WORKING DRAFT OF NEC CODE-MAKING
PANEL 15 MEETING OUTPUT

Document: National Electrical Code®

Revision Cycle: A2025

Panel Activity: Comment Stage

Figure Informational Note 517.31(A) On-Site, Off-Site, or Combination of On-Site and Off-Site Source Configuration.

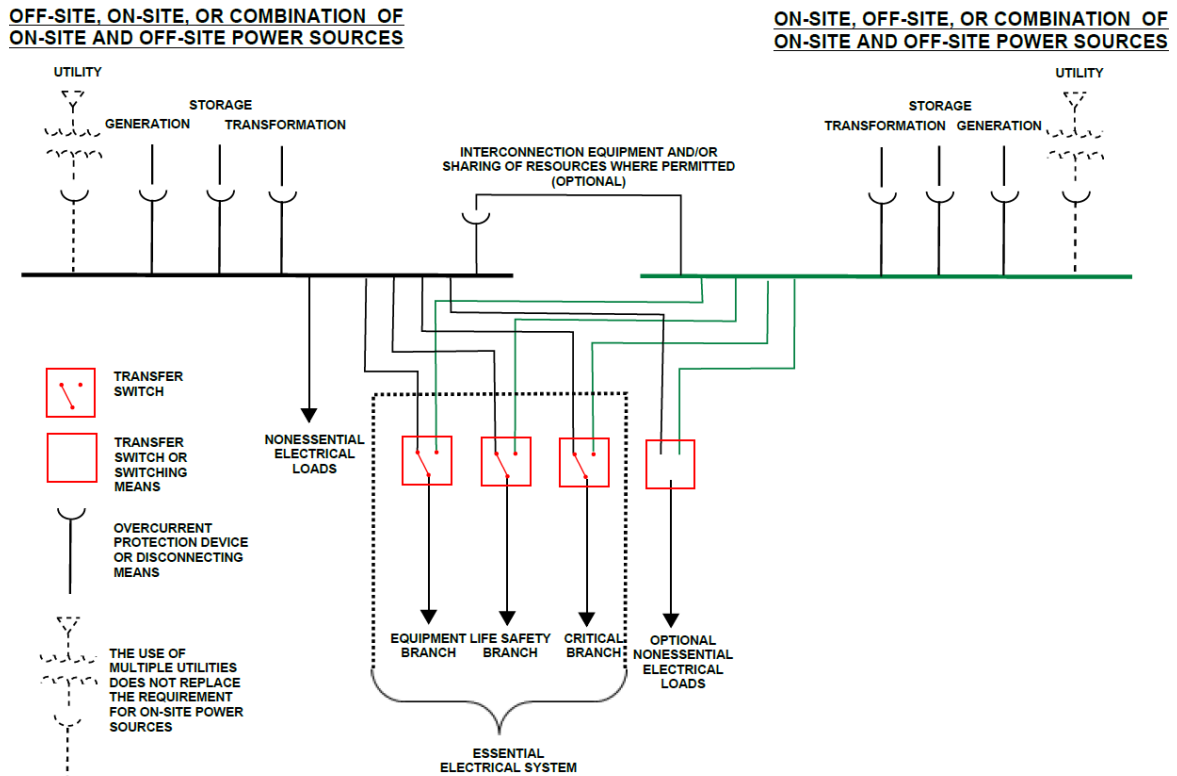
Committee Statement: New diagram provides a expansive view of what is possible and is therefore more accurate. This revision correlates with changes being made to NFPA 99. The diagram from NFPA 99 was modified to call attention to the utilities on either side of the transfer switch and a key was added with further explanation. The changes reflect the special provisions regarding utilities, that are addressed in the section.

Informational Note 1: See Figure Informational Note 517.31(A).

Figure Informational Note 517.31(B)(1) Type 1 EES — Minimum Requirement (Greater Than 150 kVA) for Transfer Switch Arrangement.

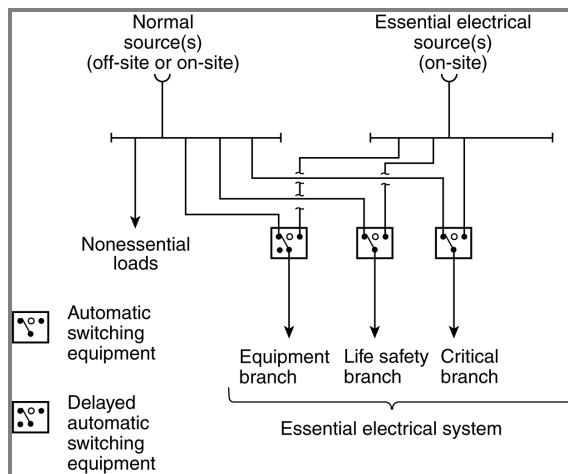
Informational Note No. 2: See Figure Informational Note 517.31(B)(1).

Figure Informational Note 517.31(B)(2) Type 1 EES — Minimum Requirement (150 kVA or Less) for Transfer Switch Arrangement.

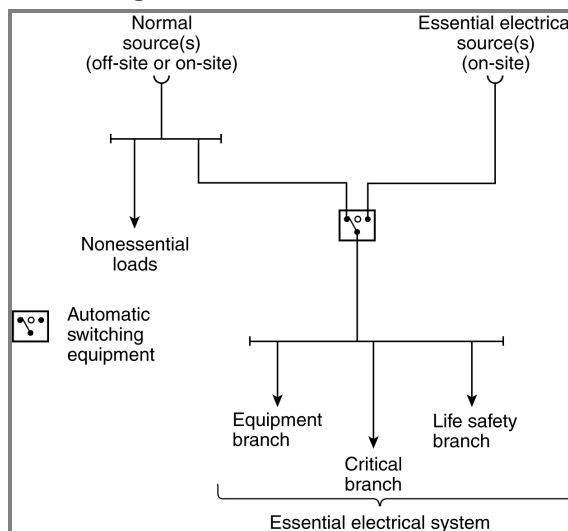
Informational Note No. 3: See Figure Informational Note 517.31(B)(2).

Figure Informational Note 517.42(B)(1) Type 2 EESs (Nursing Home and Limited Health Care Facilities) — Minimum Requirement (Greater Than 150 kVA) for Transfer Switch Arrangement.

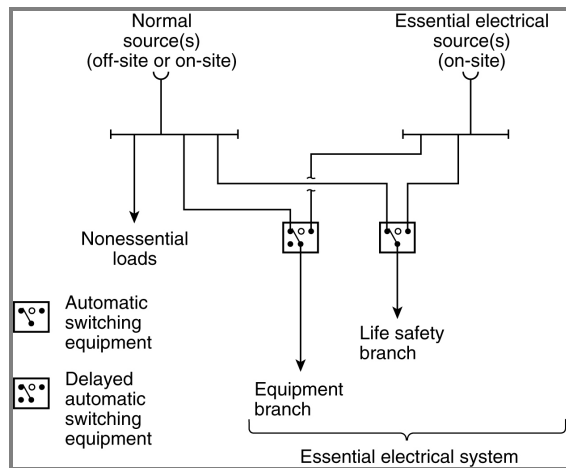
Informational Note No. 2: See Figure Informational Note 517.42(B)(1).

Figure Informational Note 517.42(B)(2) Type 2 EESs (Nursing Home and Limited Health Care Facilities) — Minimum Requirement (150 kVA or Less) for Transfer Switch Arrangement.

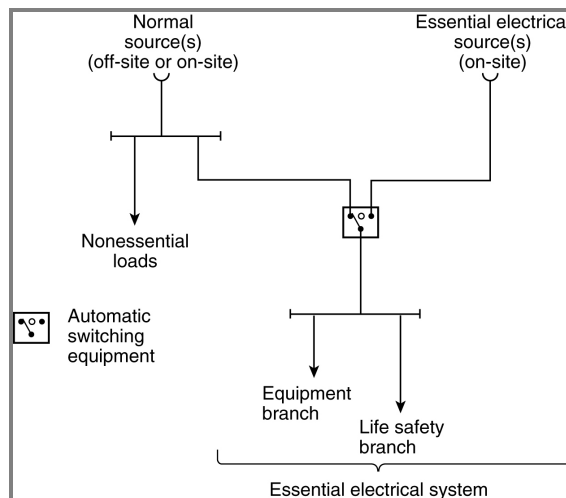
Informational Note No. 3: See Figure Informational Note 517.42(B)(2).
